AIRWORTHINESS DIRECTIVE

Grob G103 Twin II, Grob 103A Twin II Acro
Serial numbers 3501-3878 & 33879-34078

Inspection and reinforcement of welded parts of the
flight control system.

Service Bulletin
TM 315-37

Explanatory Sheet for the Execution of Instruction 1 of TM 315-37
for s/n 3501 - 3729

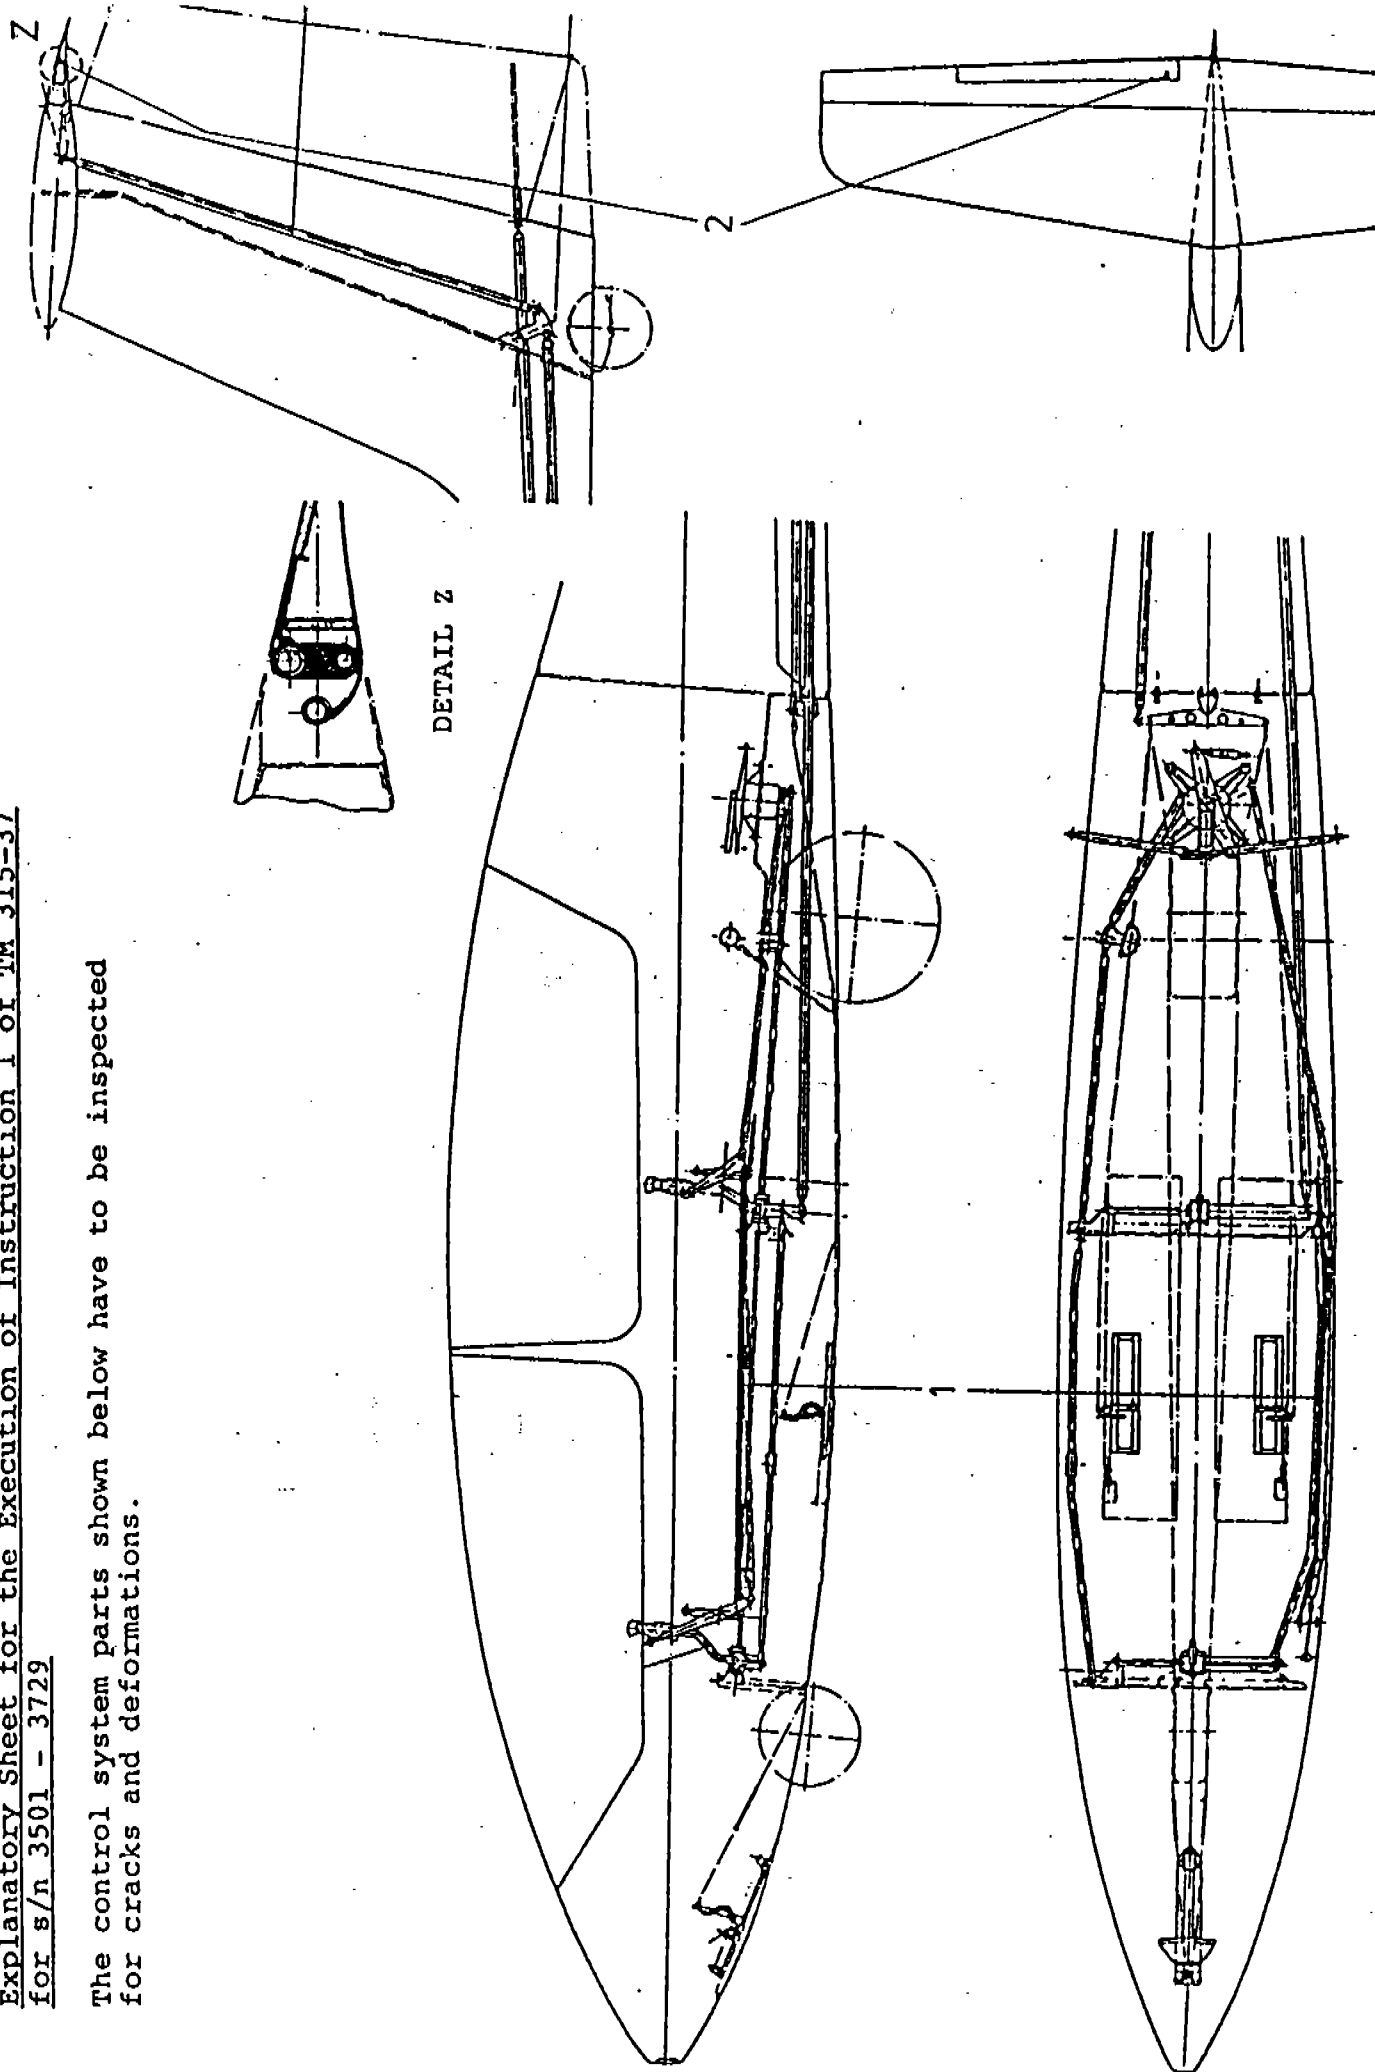
The control system parts shown below have to be inspected for cracks and deformations.
